STAFF REPORT

SUBJECT: MCU-2021-0002
Pine 43 Apartments – MCU

I. PROJECT DESCRIPTION

D. Proposed Landscape Plan, Open Space Plan (dated: 1/19/2021) & Amenity Detail

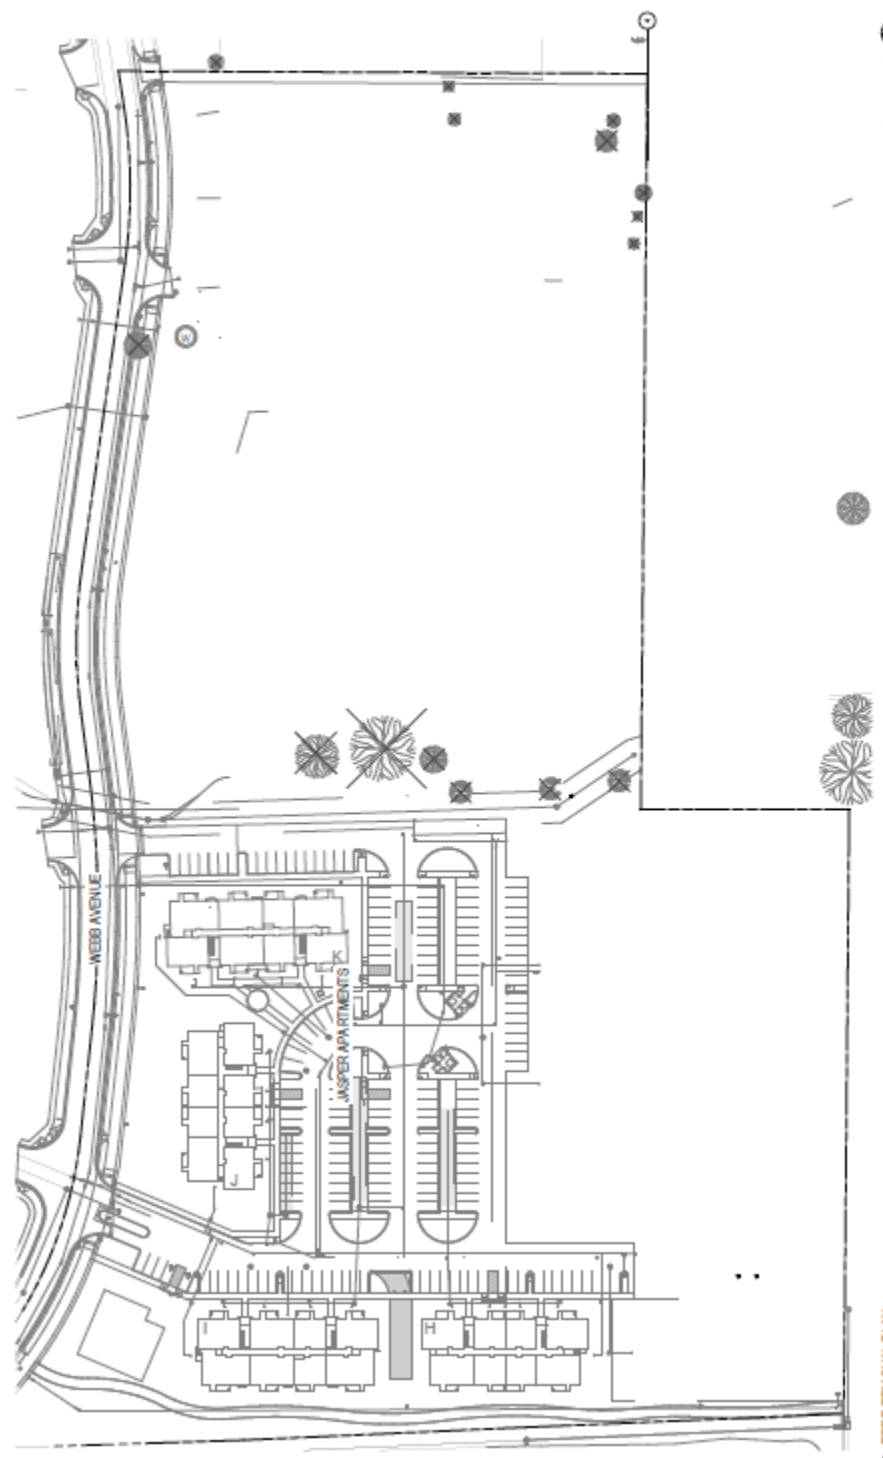
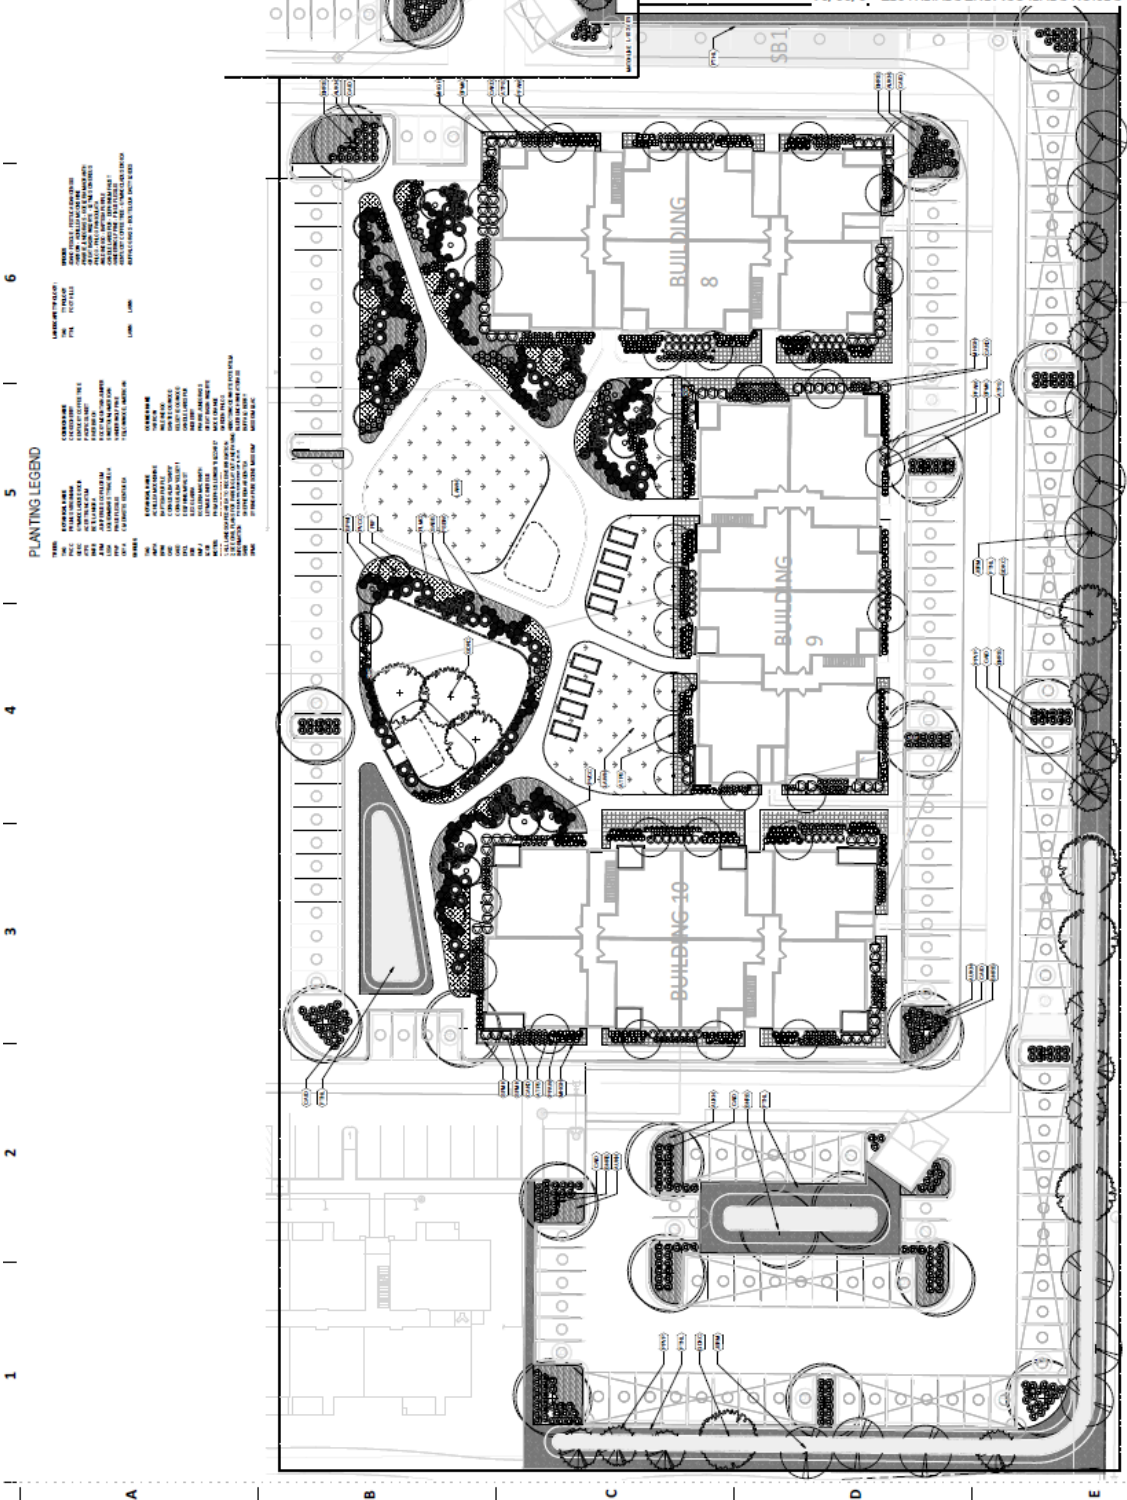
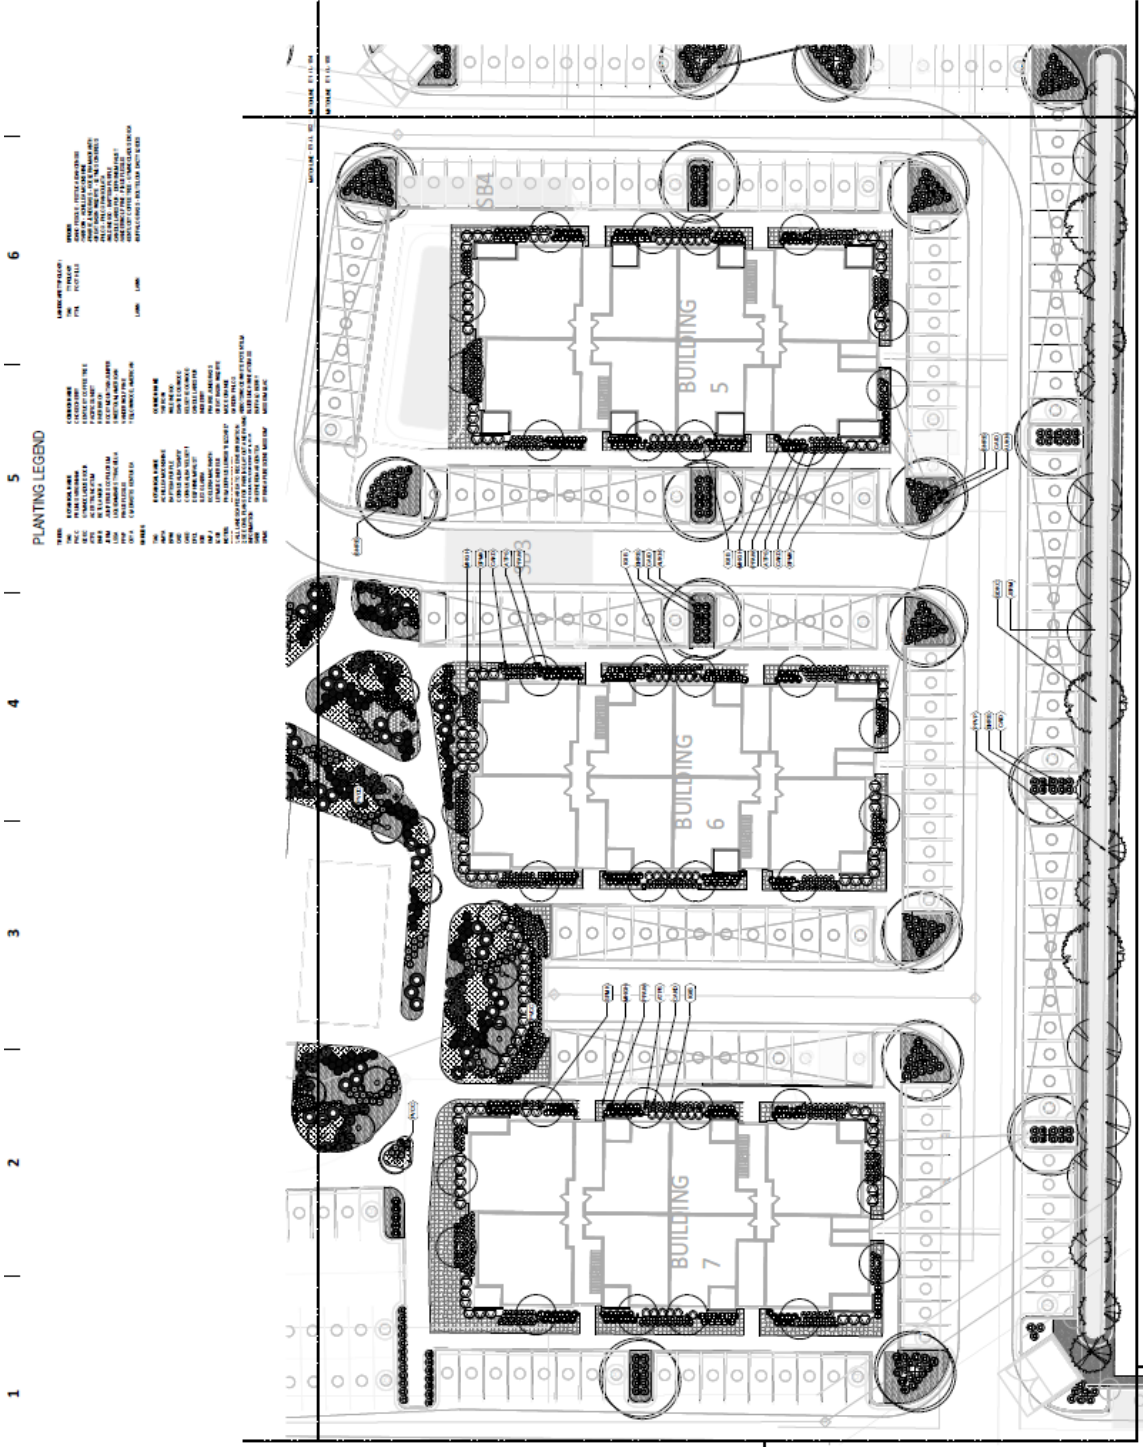
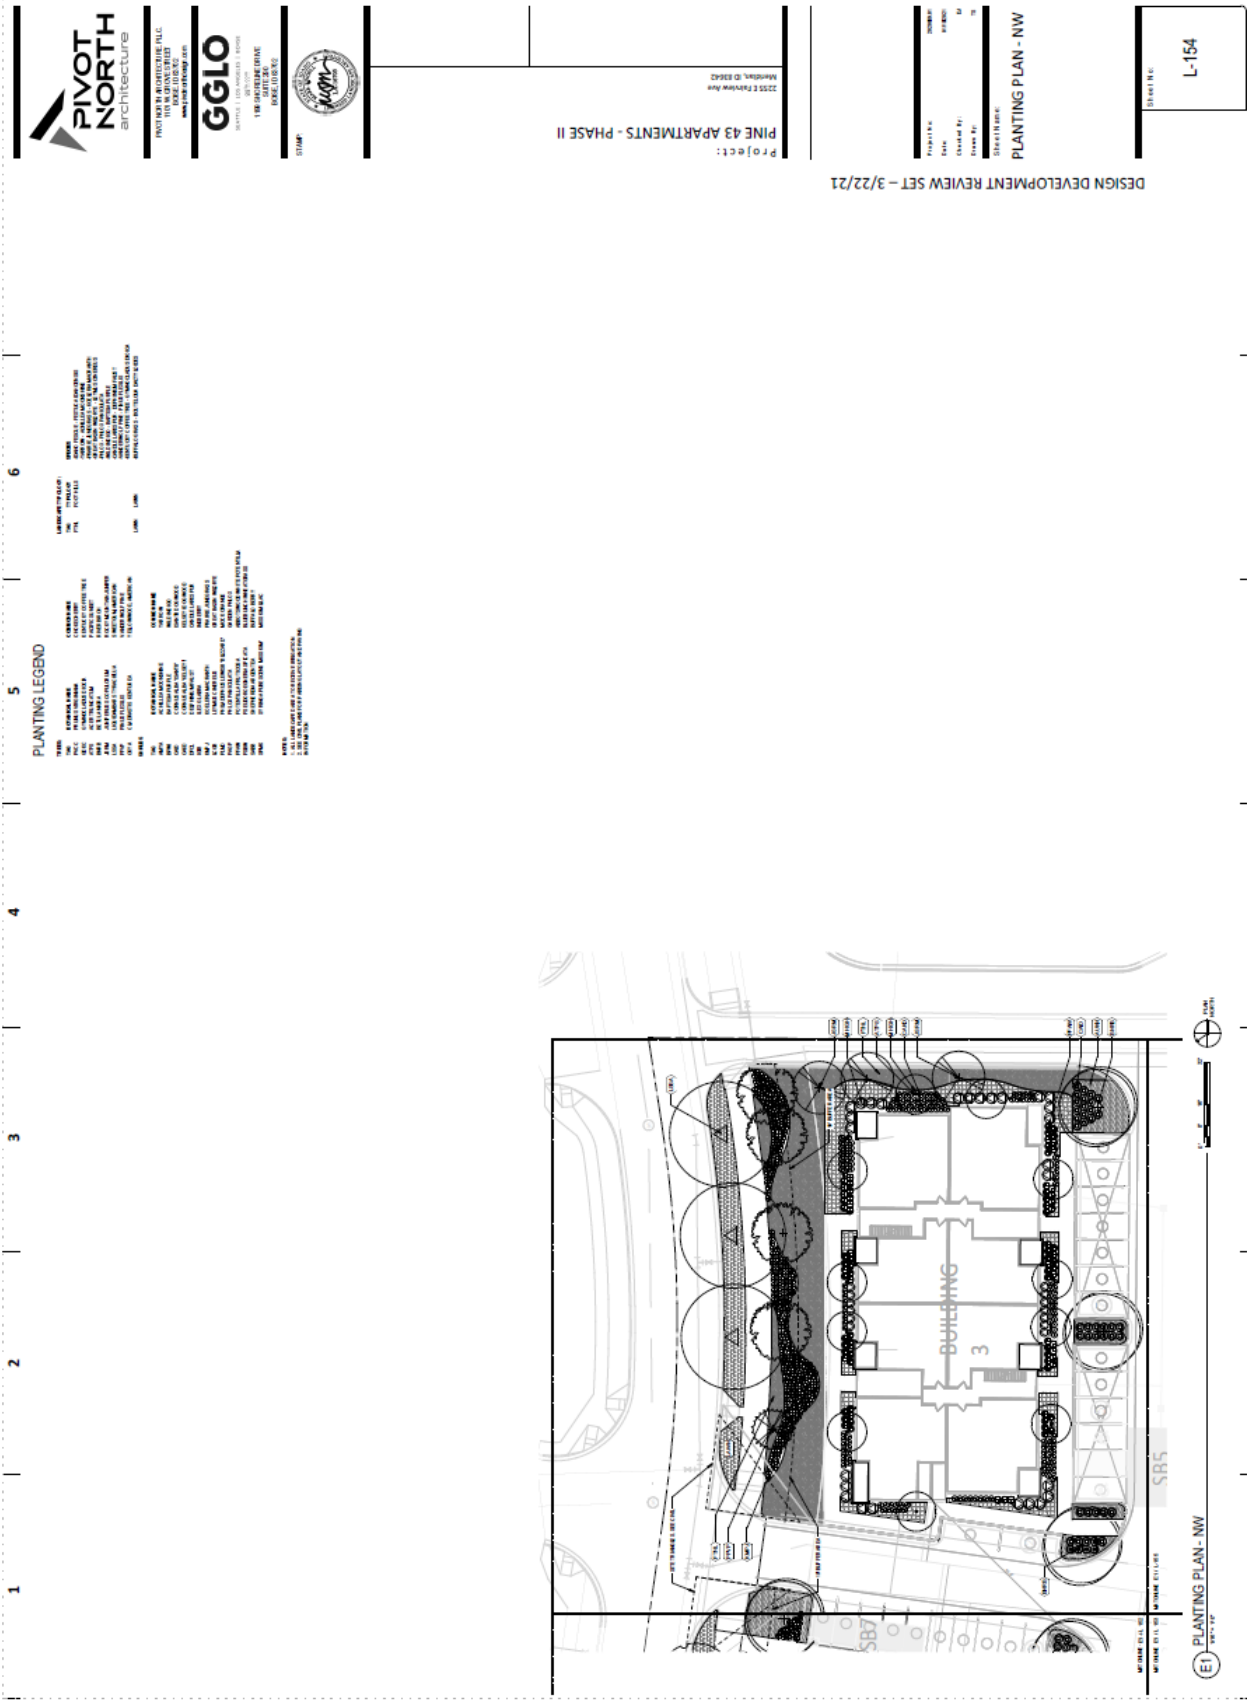
Landscaping: Landscaping proposed for the site is depicted on the landscape plan in Section VII.D. Street buffers and parkways are required to be landscaped in accord with the standards listed in UDC [11-3B-7C](#). Internal common open space areas are required to be landscaped in accord with the standards listed in UDC [11-3G-3E](#). Parking lot and perimeter landscaping is required per the standards listed in UDC [11-3B-8C](#). Landscaping is required along all pathways in accord with the standards listed in UDC [11-3B-12C](#).

Fairly dense landscaping (approximately 1 tree per 25-linear feet) is proposed in the perimeter buffer along the eastern boundary of the site adjacent to parking and industrial uses to the east. **Staff recommends a mix of evergreen and deciduous trees, shrubs, lawn or other vegetative groundcover is provided in the buffer accord with the standards listed in UDC 11-3B-9C.1.**

Mitigation is required for any existing trees removed from the site per the standards listed in UDC [11-3B-10C.5](#); the landscape plan in Section VII.D depicts the existing trees proposed for removal. **Prior to removal of any trees from the site, coordinate with Matt Perkins, City Arborist, to determine mitigation requirements (208-371-1755).** Calculations should be included on the plan demonstrating compliance with UDC mitigation standards.

Stormwater: An adequate storm drainage system shall be required in all developments in accord with the City's adopted standards, specifications and ordinances. Design and construction shall follow Best Management Practice as adopted by the City. There are some above-ground retention areas proposed along the eastern and southern boundaries of the site for stormwater management as depicted on the landscape plan in Section VII.D.

Waterways/Ditches: There is an existing irrigation ditch (Settler's Canal) that runs east/west across this site that is proposed to be relocated and piped in alignment with the new entry driveway via N. Webb Way in accord with UDC [11-3A-6](#). Buildings and trees should not be located within the easement/piped area.

- b. Depict landscaping along the multi-use pathways along N. Webb Way and the Jackson Drain in accord with the standards listed in UDC 11-3B-12C.
 - c. Depict pedestrian connections between buildings in the form of pathways distinguished from vehicular driving surfaces through the use of pavers, colored or scored concrete, or bricks in accord with the Development Agreement (provision #5.1.4b).

- d. Depict pathway/sidewalk connections to the main building entrances along N. Webb Way from the multi-use pathway along N. Webb Way.
 - e. Include mitigation information for the existing trees being removed from the site in accord with the standards listed in UDC [11-3B-10C.5](#). Coordinate with Matt Perkins, City Arborist, to determine mitigation requirements (208-371-1755).

- l. Depict landscaping within the perimeter buffer along the eastern boundary of the site as proposed (i.e. a minimum density of one tree per 25-linear feet). A *mix* of evergreen and deciduous trees, shrubs, lawn or other vegetative groundcover shall be provided in accord with the standards listed in UDC [11-3B-9C](#).

F. Proposed Conceptual Building Elevations & Perspective Drawings for Multi-Family & Clubhouse Structures **NOT APPROVED – SUBJECT TO DESIGN REVIEW APPROVAL**

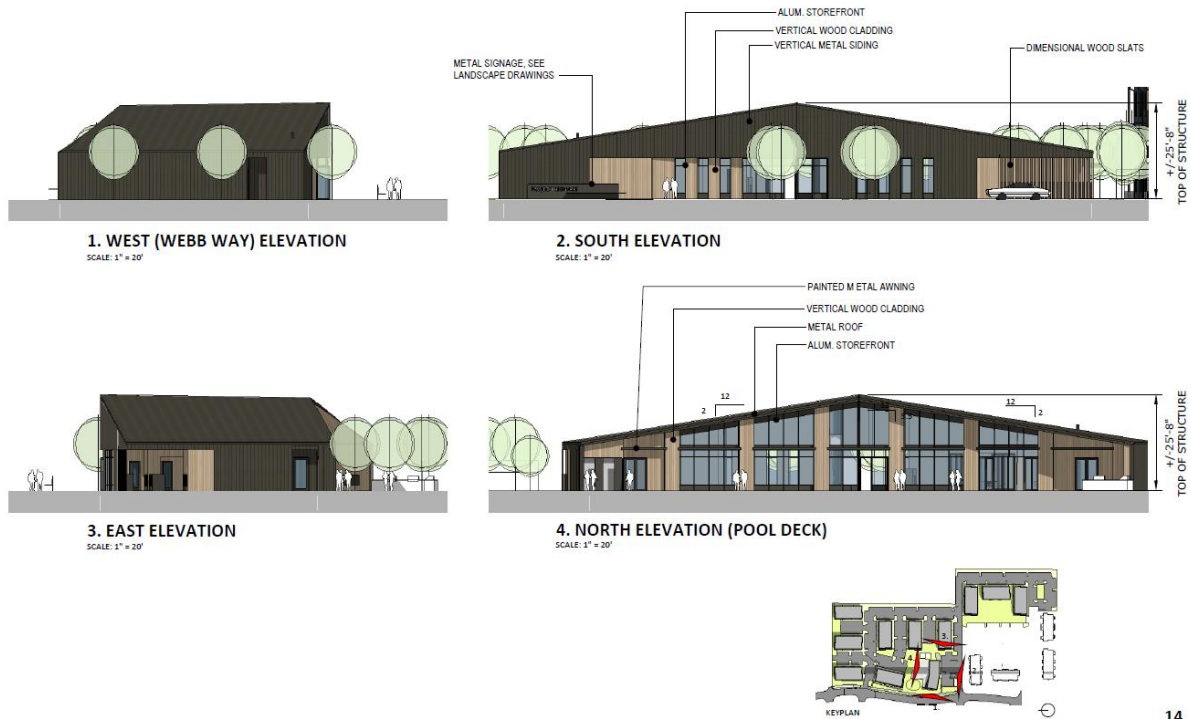
Building Elevations: Conceptual building elevations and perspective drawings were submitted for the proposed 3-story multi-family structures and the single-story clubhouse as shown in Section VII.F. Building materials for the residential structures consist of a mix of horizontal & vertical fiber cement board/batten siding with gable roofs and asphalt shingles; three primary color schemes are proposed for variety. Building materials for the clubhouse consist of vertical metal siding with vertical wood cladding, glazing, dimensional wood slat accents, a gable roof and metal roofing.

Prefabricated steel siding is only allowed to be used as an *accent* material per the development agreement (see definition on pg. E-5 of the Architectural Standards Manual and #R5.1E) – revisions should be made to comply. Additionally, per the DA, exterior building walls should demonstrate the appearance of high-quality materials of stone, brick, wood, or other native materials (acceptable materials include tinted or textured masonry block, textured masonry block, textured architectural coated concrete panels, or stucco or stucco-like synthetic materials – smooth faced concrete block, tilt-up concrete panels, or prefabricated steel panels are prohibited except as accent materials. The building design shall incorporate at least two (2) changes in one or a combination of the following: color, texture and materials. Rooflines shall demonstrate two (2) or more of the following: overhanging eaves, sloped roofs with two or more roof planes, flat roofs with varying parapet heights, or cornices.

Administrative Design Review of the proposed structures is required. All structures shall comply with the design standards listed in the Architectural Standards Manual. The elevations submitted with this application are *not* approved and will likely require further modifications to comply with design standards. Per the Architectural Standards Manual (ASM), architectural elements should be provided to clearly distinguish between the ground level and upper stories (ASM Goal #R3.1E); visually heavier and more massive elements or materials should be provided at the base of buildings with lighter elements and materials above (#R3.1F); horizontal and vertical elements should be integrated into facades to break up monotonous wall planes (#R3.20); 25% or more of the non-roof surface area of the clubhouse (i.e. accessory structure) must utilize a like material of the primary structures (#R3.3B); locate focal points as key elements within the building design to enhance architectural character (#R4.20); incorporate a trim color and an accent color or unique material into the color scheme as integrated details of the building design (#R.5.2A); modulate and articulate roof form of the clubhouse to create building profile interest and to reduce the appearance of building mass and scale (#R3.4).

The elevations in the first phase of the multi-family development lying directly to the southwest of this site (i.e. Jasper Apartments) are a different architectural style (flat roofs with parapets and more of a modern style – see Section VII.E) and color palette but the proposed structures incorporate

several orientations of fiber cement board siding which assist in unifying the structures. The Applicant anticipates the existing structures will be re-painted in the future to coincide with the proposed color scheme. While different architecturally, Staff feels the similar use of materials and colors will offer variety within the development.

12. All future structures shall comply with the design standards in the Architectural Standards Manual and in the [Development Agreement](#). Exterior building walls should demonstrate the appearance of high-quality materials of stone, brick, wood, or other native materials (acceptable materials include tinted or textured masonry block, textured masonry block, textured architectural coated concrete panels, or stucco or stucco-like synthetic materials – smooth faced concrete block, tilt-up concrete panels, or pre-fabricated steel panels are prohibited except as accent materials as set forth in the Development Agreement (provision #5.1.4h). *See notes in Section V under Building Elevations.*
